RE: Warner Park Community Recreation Center Expansion – Initial-Final Presentation

Engberg Anderson is pleased to submit an application to the Urban Design Commission for the design of the Warner Park Community Recreation Center expansion, planned for 1625 Northport Drive. The informational presentation for this project on March 29th brought up three major points which the notes below and supporting documentation address:

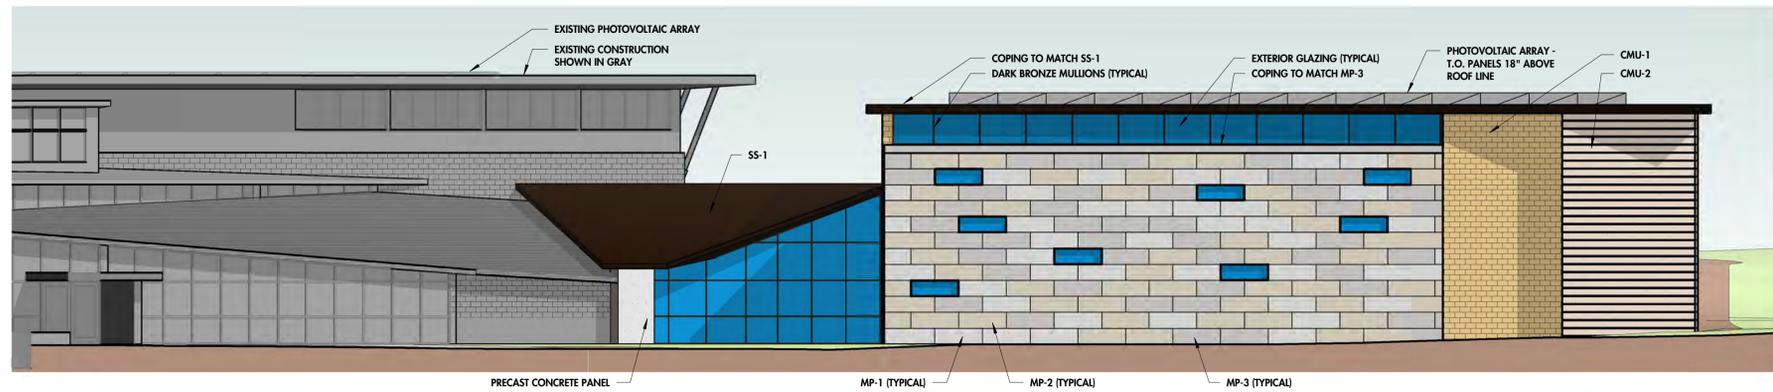
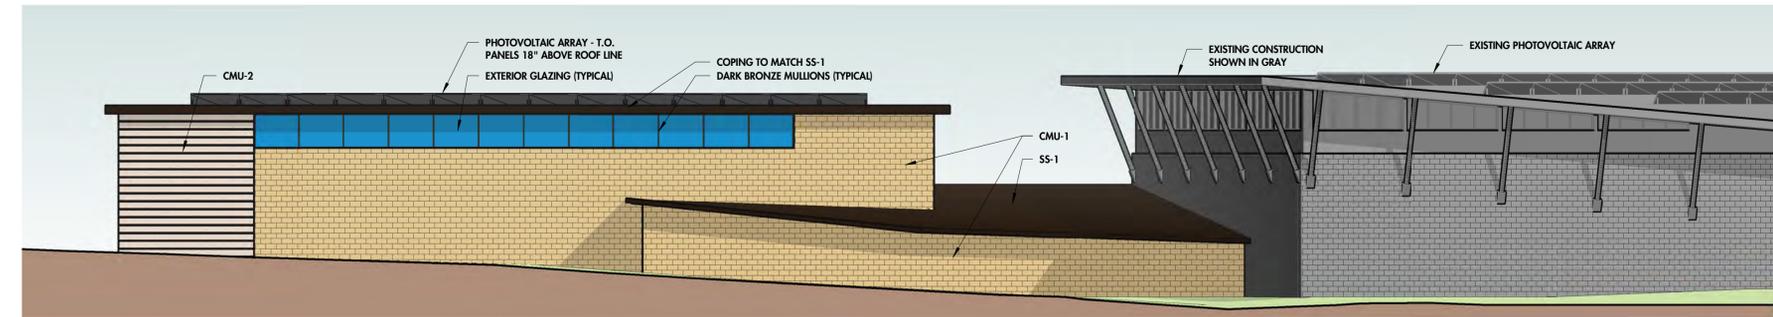
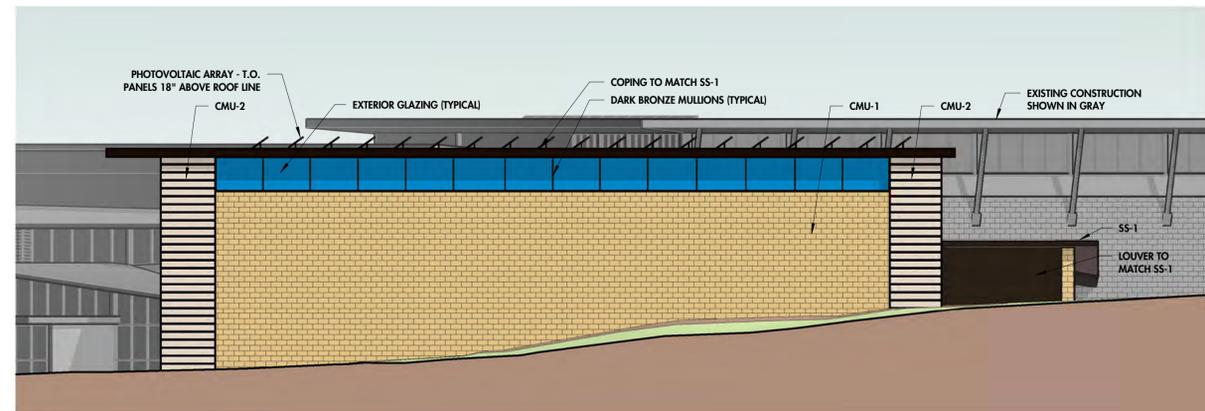
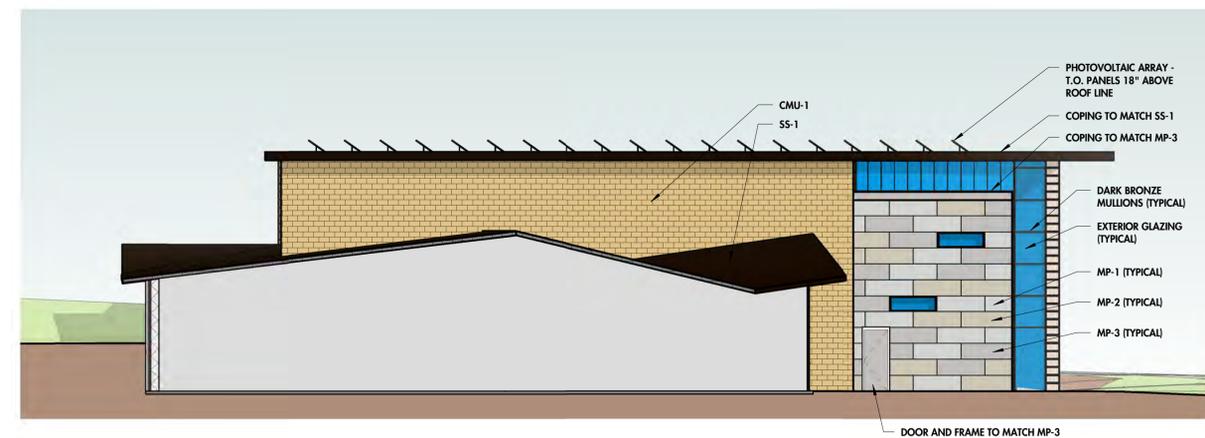
The roofline of the existing building is one of its identifying features; it's unique, elegant. Consider making refinements to the roof angle on the proposed addition.

Response: The objective of our expansion design is to blend in with the existing high style of the community center design. Adding onto the southeast means the existing gymnasium is at the center of the new building footprint. The expansion design pulls its design and material vocabulary from the existing palette but also allows the existing gymnasium to become a centerpiece with unique design elements, such as the structural kickers and sloping roofline. The mass of the new gymnasium serves as a secondary element, with simplified details and a step down in height. The new gymnasium also incorporates an angled high roof which is accentuated with clerestory windows along the south, east, and north facades to complement the existing angled roof planes.

The sharp angle of the butterfly roof along the south wall of the pre-function area ties into and adds to the existing lower roof language along the building, which is accentuated by placing floor-to-roof storefront below it. An additional roof pitch on the north side above the mechanical room references similar gestures across other lower roofs on the existing building.
